NORTH LINCS S51 ADVICE – EST INPUT – 12 April 2022

Environmental Statement (ES) (Volume 6)

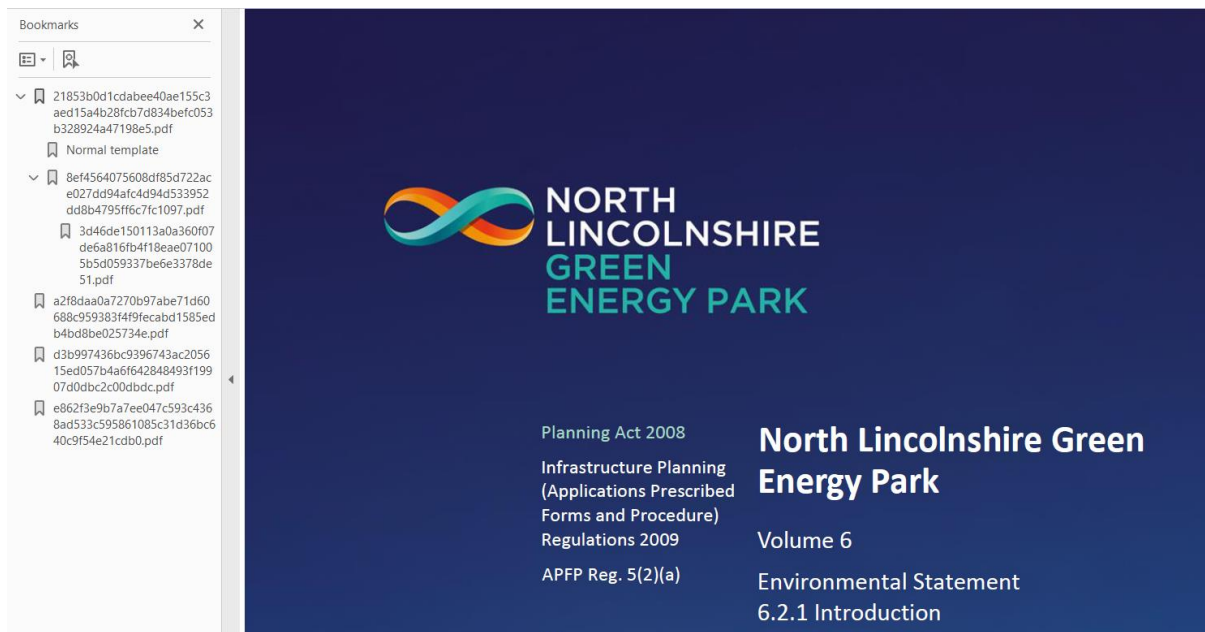
To assist readers in navigating through documents, it would be useful if the bookmarks within the pdfs be revised to show the index/section headings rather than arbitrary links. An example image is set out below.
